HISTORIC AND DESIGN REVIEW COMMISSION

HDRC CASE NO: 2020-346

COMMON NAME: 5423 Hot Wells Way/ Hot Wells Development

TYPE OF WORK: Construction of a spa and site work north of Hot Wells County Park

Phase 1 - Site Plan

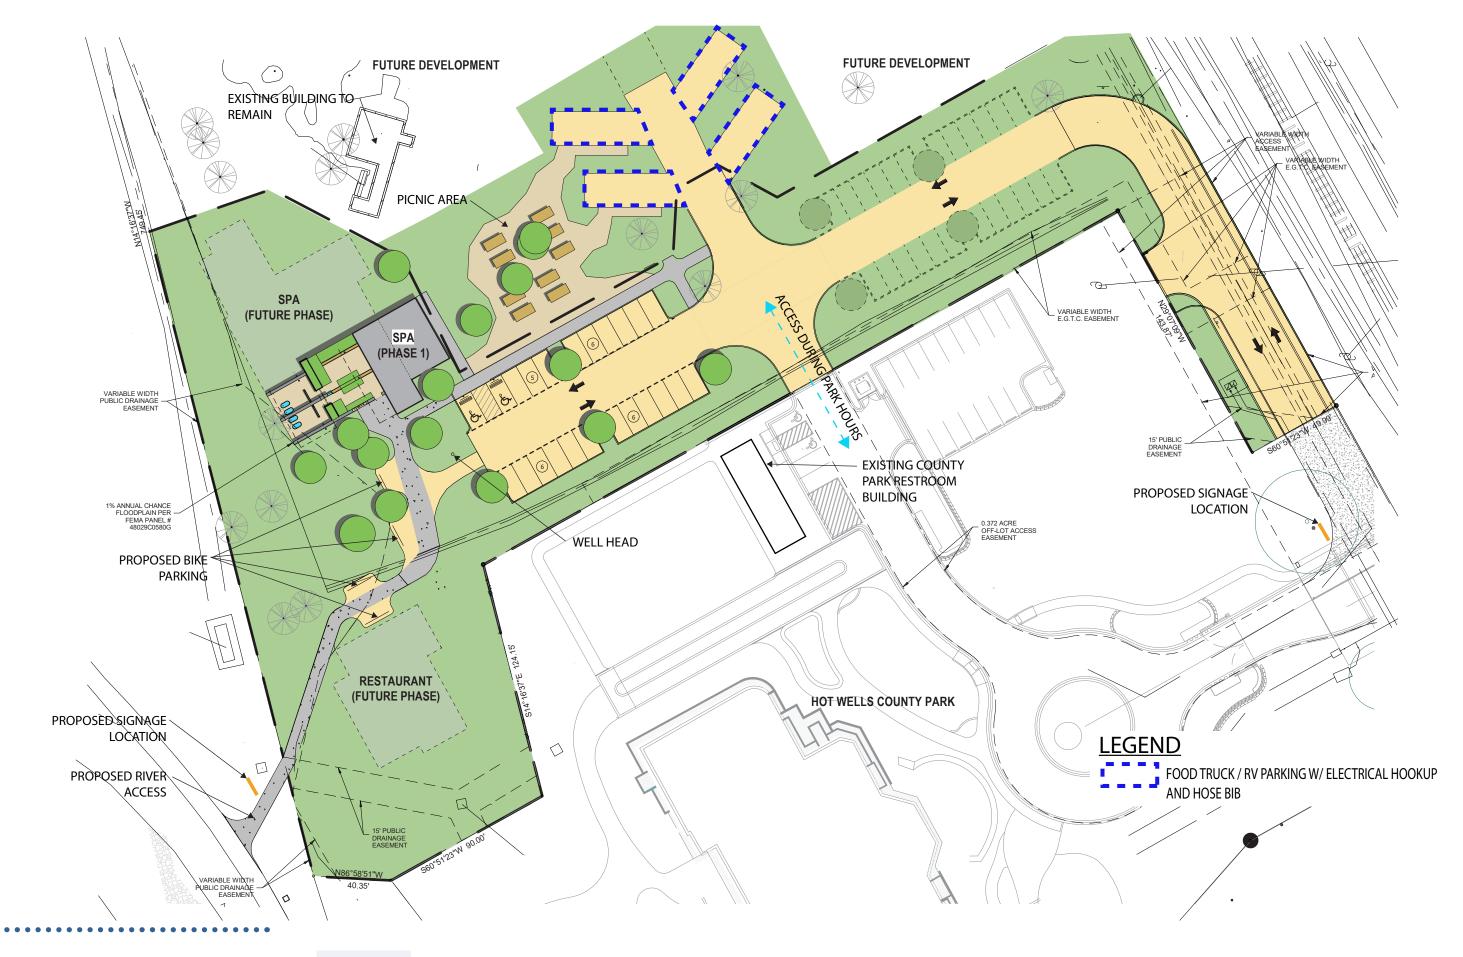
- f. SITE DESIGN According to the UDC Section 35-673, buildings should be sited to help define active spaces for area users, provide pedestrian connections between sites, help animate the street scene and define street edges. Staff finds that the applicant has deigned a site that defines active space in a campus like setting. This is consistent with the UDC.

- g. SITE SETBACKS The Unified Development Code Section 35-673 notes that new construction in RIO-5 must feature a fifty (50) foot setback from the top of bank. Per the site plan, staff finds that the applicant has met this requirement.

- i. LANDSCAPE DESIGN The applicant has provided landscaping information on the conceptual site plan. The applicant is responsible for complying with the UDC in regards to landscape design.

- i. That the applicant coordinate with the San Antonio River Authority regarding landscaping and maintenance boundaries, direct access to the river and storm water control.
- ii. That all mechanical equipment be screened from view at the public right of way.
- iii. That the applicant recess windows at least two inches within walls and that windows feature dark colors.
- iv. That a detailed landscaping plan be submitted for review and approval when returning to the Commission for final approval.
- v. ARCHAEOLOGY Archaeological investigations are required. The project shall comply with all federal, state, and local laws, rules, and regulations regarding archaeology, as applicable.
